### **Merged Document Report**

### **Application No.: PL9049**

| Record Type : | PLAT |

# KASPIAN SUBDIVISION PRELIMINARY PLAT

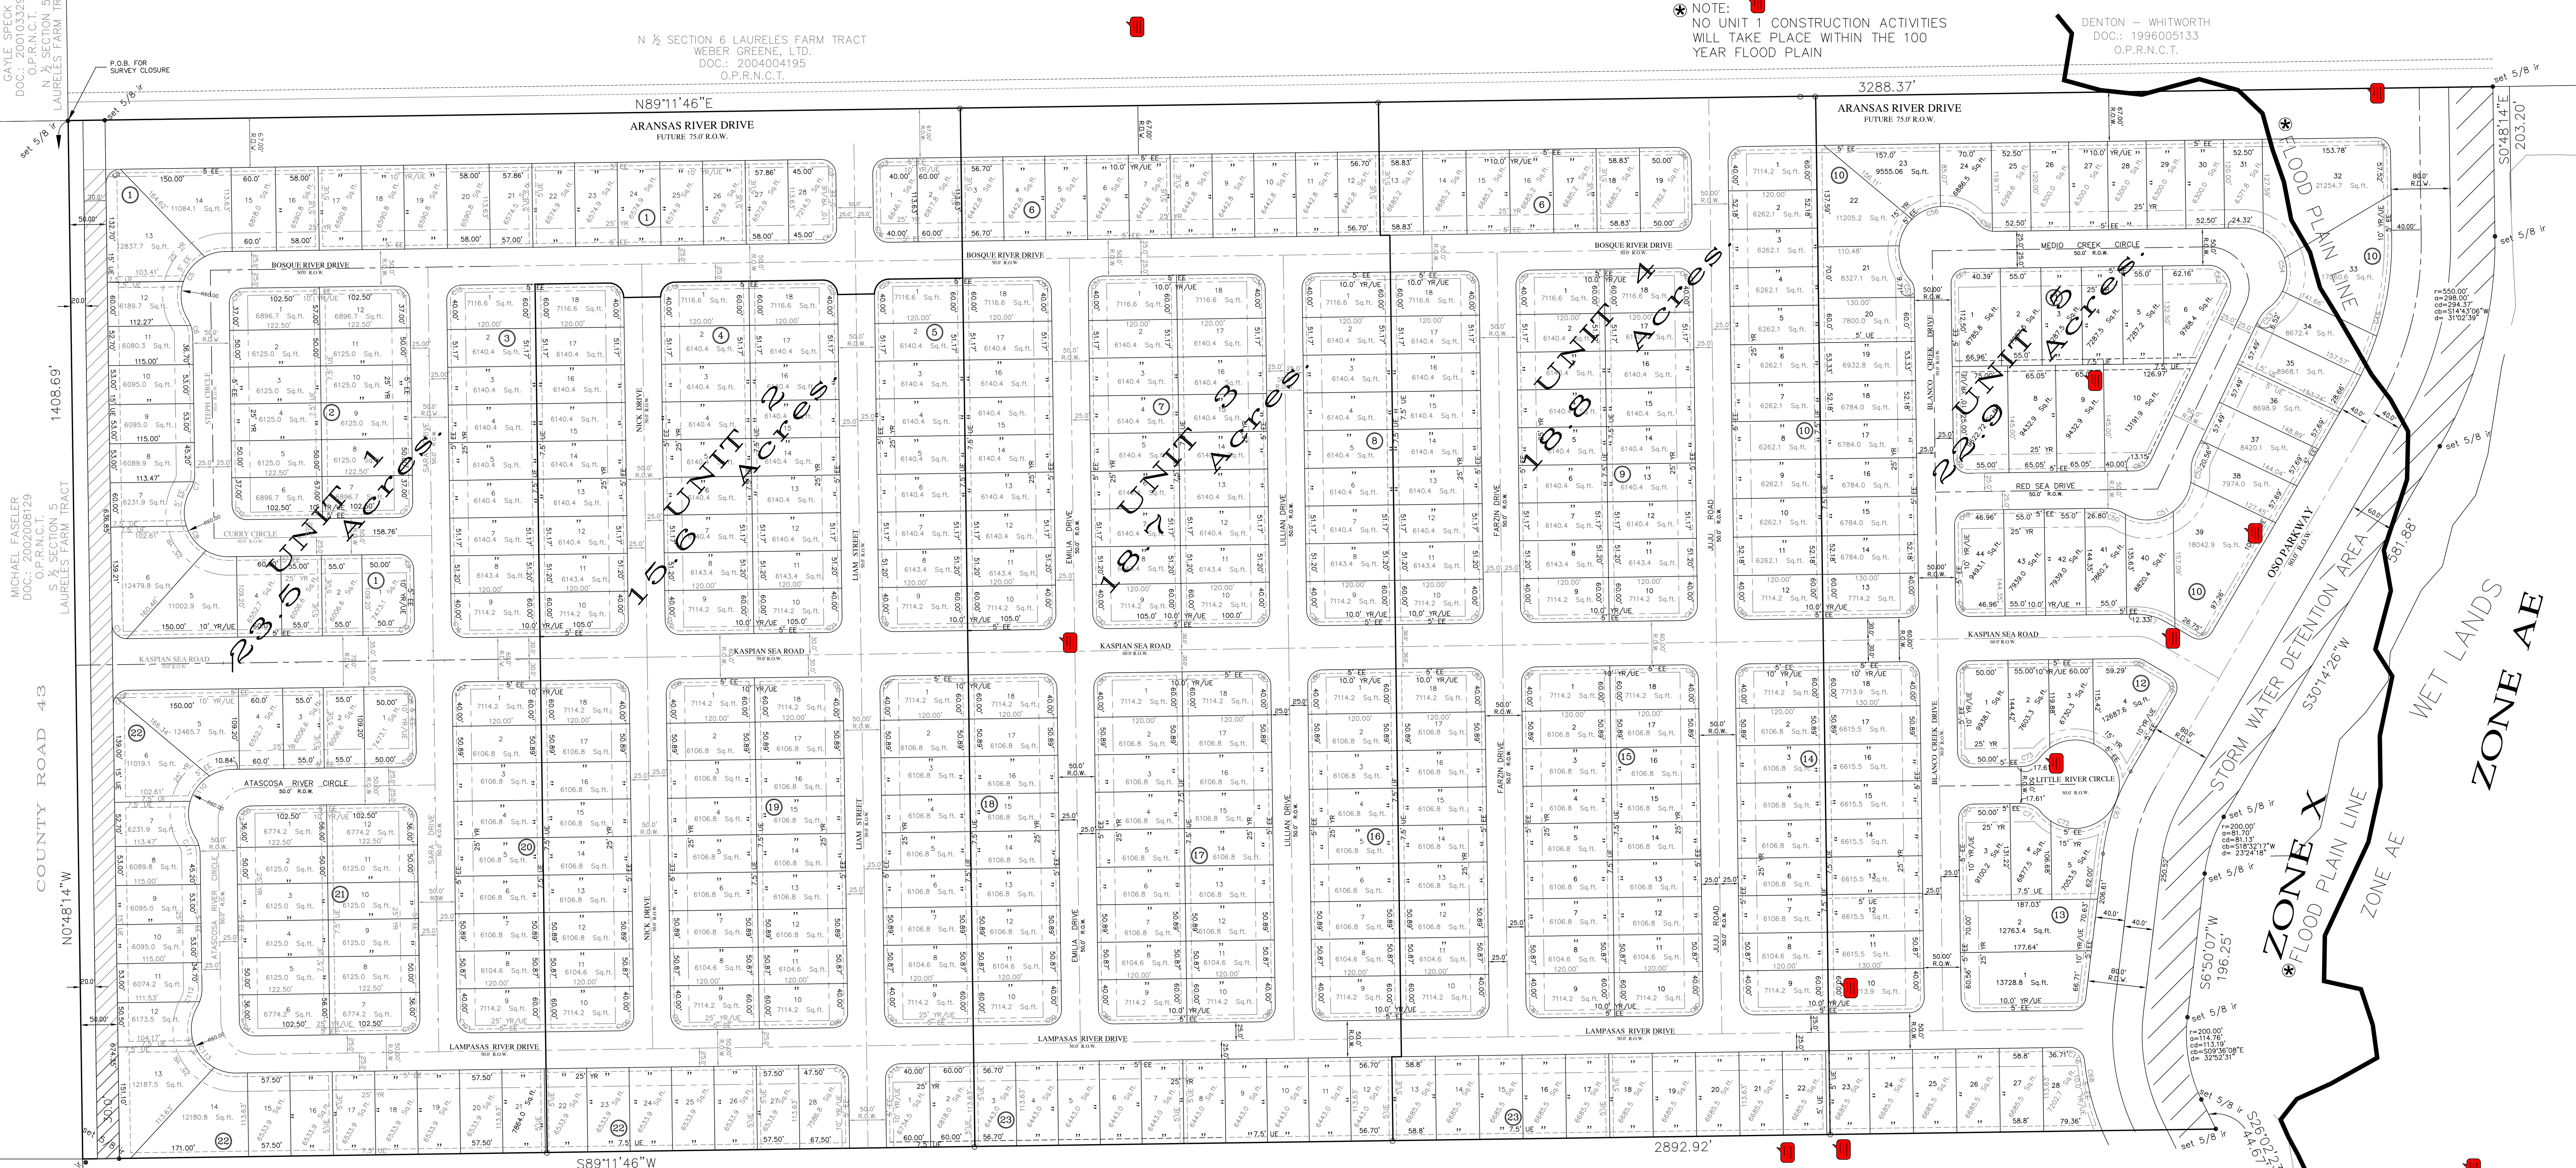
| Comment ID | Page Reference | Annotation Type | Author : Department | Status   | Review Comments  | Applicant Response Comments |
|------------|----------------|-----------------|---------------------|----------|--|-----------------------------|
| 17         | P001           | Note            | Bria Whitmire : DS  | Closed   | Appears to be an excessive straight away without stop conditions - are any traffic calming measures proposed?  |                             |
| 19         | P001           | Note            | Bria Whitmire : DS  | Closed   | This put a residential roadway abutting property to the south which could possibly abut back yards. Possible to keep Lampasas going straight to Blanco Creek with <150' dead end to reduce the impact of this condition?   |                             |
| 26         | P001           | Note            | Bria Whitmire : DS  | Closed   | Unit 1 is towards FM 43 is it not? Is this note referencing Unit 5?  |                             |
| 27         | P001           | Note            | Bria Whitmire : DS  | Closed   | This street configuration appears to be very close for fire apparatus. Confirm ability of fire apparatus to maneuver either end of this road section along southern property line.   |                             |
| 29         | P001           | Note            | Mina Trinidad : DS  | Closed   | <p>Traffic/ROW:<br/>(Jorge Chavez)</p> <p>ROADWAY MASTER PLAN (RMP) Comments:<br/>C3 Collector (East / West), north side of proposed development (Aransas River Drive)<br/>As per RMP &amp; Infrastructure Design Manual (IDM) -</p>   |                             |

| Comment ID | Page Reference | Annotation Type | Author : Department | Status | Review Comments   | Applicant Response Comments |
|------------|----------------|-----------------|---------------------|--------|---|-----------------------------|
|            |                |                 |                     |        | <p>75 FT ROW dedication required<br/>Accompanied Public Improvements for a 75 FT ROW, as per IDM Section 6.2.2.B Non-Local Street Standard Table<br/>Plat proposed ROW dedication, Aransas River Drive, of 67 FT (Future ROW 75 FT)<br/>Clarify, half / half ROW dedication is the typical approach for planed roadways split between two future developments (plats / parcels).<br/>Clarify, will this development propose public improvements for the majority of the planned C3 collector, if so , how much?<br/>Provide street typical section as per IDM Section 6.2.2.B Non-Local Street Standard Table - 75 FT ROW for review and approval.</p> <p>A3 Arterial (North / South), west side of proposed development (County Road 43)<br/>As per RMP &amp; IDM - 130 FT ROW dedication required<br/>Accompanied Public Improvements for a 130 FT ROW, as per IDM Section 6.2.2.B Non-Local Street Standard Table<br/>Plat proposed ROW dedication of 30 FT (County Road 43)<br/>Does not meet required proposed ROW as per RMP &amp; IDM requirements<br/>Update plat to show ROW dedication as per RMP &amp; IDM requirements<br/>Provide street typical section as per IDM Section 6.2.2.B Non-Local Street Standard Table - 130 FT ROW for review and approval.</p> <p>P1 Parkway Collector (North / South), east side of proposed development (next to Storm water dentation area)<br/>As per RMP &amp; IDM - 80 FT ROW dedication required<br/>Accompanied Public Improvements for an 80 FT ROW, as per IDM Section 6.2.2.B Non-Local Street Standard Table<br/>Plat proposed ROW dedication of 80 FT<br/>Plat meets required proposed ROW as per RMP &amp; IDM requirements<br/>Provide street typical section as per IDM Section 6.2.2.B Non-Local Street Standard Table - 130 FT ROW for review and approval.</p> <p>TRAFFIC Comments:<br/>Street typical to reflect criteria as per the City of Corpus Christi Infrastructure Design Manual (IDM), Chapter 6 Local &amp; Non-Local Street Standard Street typical(s), clarify the classification of each</p> |                             |

| Comment ID | Page Reference | Annotation Type | Author : Department | Status | Review Comments  | Applicant Response Comments |
|------------|----------------|-----------------|---------------------|--------|--|-----------------------------|
|            |                |                 |                     |        | <p>proposed typical street section<br/>As per the Unified Development Code(UDC) Section 8.2.1.D<br/>Two (2) points of external access, minimum, must be provided if the development has more between 81 to 160 buildable lots in a subdivision.<br/>Three (3) points of external access, minimum, must be provided if the development has more than 161 buildable lots in a subdivision.<br/>Proposed Driveway access for both the development as a whole and individual parcel connecting to public City Street shall conform to access management standards outlined in Article 7 of the UDC (UDC 7.1.7)</p>   |                             |
| 30         | P001           | Note            | Mina Trinidad : DS  | Closed | <p>03/09/26 Update: Plat closes within acceptable engineering standards.</p> <p>02/04/26 Update: Plat does not close within acceptable engineering standards.</p> <p>GIS:<br/>(Ziba A)<br/>Upon review, I was unable to find the bearings and distances for the outer boundary of this property to perform a closure check.<br/>Could you please provide a copy of the plat that includes these specific dimensions?</p>   |                             |
| 31         | P001           | Note            | Mina Trinidad : DS  | Closed | <p>03/19/26 Update: Comments of the easements being added to the plat is fine.</p> <p>03/06/26 Update: It appears that the 5'UEs on Lots 22 and 23 Blk 23 have been removed on this latest version for submittal. The Gas Department would like to request that these easements be put back on those lots. We need at least one of them for looping/back feed purposes, not sure why they were removed.</p> <p>02/02/26 Update: Gas Department would like to request a 5' UE on Lot 20 BLK 10 and a 5' UE on Lot 12 BLK 14 as shown on attached map.<br/>(Under attachments in Customer Portal)</p> <p>Gas Department:<br/>(Keith Rodriguez)<br/>Please see attached for gas easements requested in red for Kaspian Subdivision.</p> |                             |

| Comment ID | Page Reference | Annotation Type | Author : Department | Status | Review Comments   | Applicant Response Comments |
|------------|----------------|-----------------|---------------------|--------|---|-----------------------------|
| 34         | P001           | Note            | Mina Trinidad : DS  | Closed | Increase street text within vicinity map  |                             |
| 35         | P001           | Note            | Mina Trinidad : DS  | Closed | Revise general note #2. Property is zoned RS-4.5.   |                             |
| 36         | P001           | Note            | Mina Trinidad : DS  | Closed | Include receiving waters plat note.   |                             |
| 37         | P001           | Note            | Mina Trinidad : DS  | Closed | In the plat notes, include the Fema Flood Information note with the effective date of October 13, 2022.   |                             |
| 40         | P001           | Note            | Mina Trinidad : DS  | Closed | Block 11, Lots 8, 9, & 10 required to show square footage of lot.   |                             |
| 46         | P001           | Note            | Mina Trinidad : DS  | Closed | General note #17 can be removed as it is a duplicate of general note #2.  |                             |
| 47         | P001           | Note            | Mina Trinidad : DS  | Closed | Add the current owner's name to the plat as well.   |                             |
| 6          | P001           | Note            | Caleb Wong : STREET | Closed | PW STR: Informational - For future reference, please revise the typical section drawings to be consistent in design with Aransas River, 50' ROW and 60' ROW typical sections. Other typical sections do not match the same format.  |                             |
| 7          | P001           | Note            | Caleb Wong : STREET | Closed | PW STR: The developer shall be required to utilize the most stringent of sections per classification of roadway without a Geotech report validating the soil type. Please refer to IDM when constructing pavement section.<br><br>PW STR: Was a Geotech report acquired for this area? Without it, we cannot accept the design of the typical sections.   |                             |

| Comment ID | Page Reference | Annotation Type | Author : Department | Status | Review Comments  | Applicant Response Comments |
|------------|----------------|-----------------|---------------------|--------|--|-----------------------------|
| 8          | P001           | Note            | Caleb Wong : STREET | Closed | PW STR: Per IDM Table 6.3.5H, the road section cross-slope from the crown to the gutter shall be a consistent 2% minimum.  |                             |
| 9          | P001           | Note            | Caleb Wong : STREET | Closed | PW STR: Per IDM Table 6.3.5J, One coarse surface treatment/underseal would be required between the base and asphalt pavement.<br><br>PW STR: Please adjust arrow of one-course surface treatment and prime coat callouts to point between asphalt and base layers for all typical street sections.   |                             |
| 10         | P001           | Note            | Caleb Wong : STREET | Closed | PW STR: Per IDM table 6.3.5H, the treated subgrade and flexible base shall extend at least 2 feet beyond the back of curb.<br><br>PW STR: Please add note to all proposed street sections for consistency.   |                             |
| 11         | P001           | Note            | Caleb Wong : STREET | Closed | PR STR: Will CR 43 be improved? CR 43 is on the Roadway Master Plan and is classified as a secondary arterial (A2) and shall have the appropriate ROW per the IDM Table 6.2.2.B.<br><br>PW STR: Note on CR 43 typical section refers to IDM Table 6.3.5KA but that table refers to Minor Residential Collectors while CR 43 is slated to be an A2 Arterial. The appropriate table is IDM Table 6.3.5M. Note also mentions that the typical section is for CR 43 within the limits of development. What about off site and how far off site? Will construction of CR 43 reach Weber Rd? Please adjust note. |                             |
| 12         | P001           | Note            | Caleb Wong : STREET | Closed | PW STR: Kaspian Sea Rd has a label of 70' ROW on a section that is drawn to 60' ROW. What is the reason for the ROW shift and how will that be constructed. Please provide typical section for both ROW proposals.<br><br>PW STR: Since the medians will be in City/Public ROW, the medians shall be constructed with concrete with no green space. For more information, please contact Public Works Stormwater Department.   |                             |
| 13         | P001           | Note            | Caleb Wong : STREET | Closed | PW STR: What type of divider will be in place between Little River Circle and Oso Parkway?<br><br>PW STR: A non-mountable curb separation will be required and proper protection implemented between the two streets. In addition, a form of traffic deterrence (bollard or barricade) will need to be installed to prevent vehicles passing though.   |                             |

| Comment ID | Page Reference | Annotation Type | Author : Department | Status | Review Comments  | Applicant Response Comments |
|------------|----------------|-----------------|---------------------|--------|--|-----------------------------|
| 14         | P001           | Note            | Caleb Wong : STREET | Closed | PW STR: King's Lake West subdivisions is directly below. Will Blanco Creek Dr be abutting the backyards of the houses south in the adjacent subdivision?   |                             |
| 41         | P001           | Note            | Caleb Wong : STREET | Closed | PW STR: Please add Oso Parkway label to the site map.  |                             |
| 42         | P001           | Note            | Caleb Wong : STREET | Closed | PW STR: Typical 80' ROW typical section shows a 5' sidewalk and a 10' shared bike path. Is the 5' sidewalk callout to denote that 5' of the 10' shared bike path will be for pedestrians?  |                             |
| 43         | P001           | Note            | Caleb Wong : STREET | Closed | PW STR: Oso Parkway typical shows geotextile. Geotextile will need to follow IDM Table 6.3.5E - Geogrid Requirements   |                             |
